**Report for:** Head of Service for Highways and Parking in consultation with Cabinet Member for Tackling Inequality and Resident Services

**Title:** Proposed waiting and loading restrictions and parking place changes, batch 2023-03 at 15 locations within various wards across the borough

To report on the feedback of statutory consultation carried out from 2<sup>nd</sup> August to 23<sup>rd</sup> August 2023 on the proposal to introduce waiting and loading restrictions and parking place changes at various locations across the borough, as detailed in Table 1 Section 6.

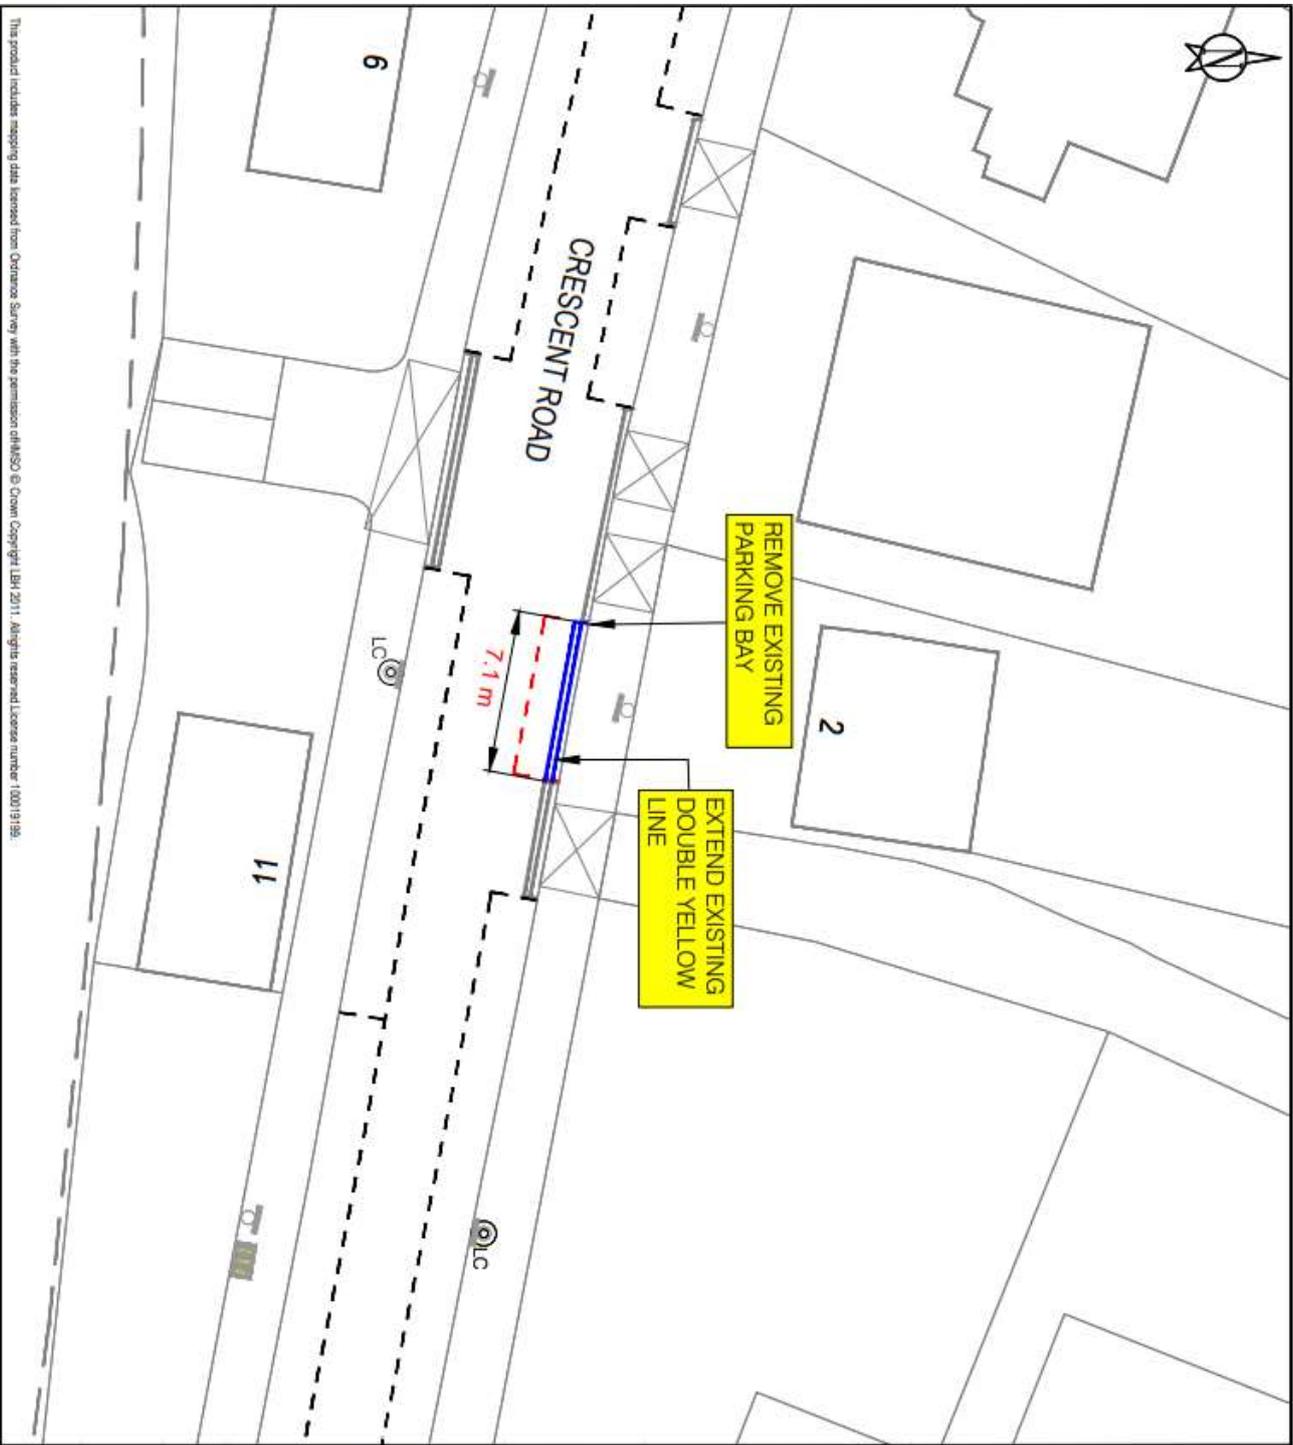
(c)	Colless road N15	Removing parking bays and extend double yellow lines on Colless road by 4.5m towards wakefield road junction	At any time	Allow safer access to parking, improve footway safety for pedestrians
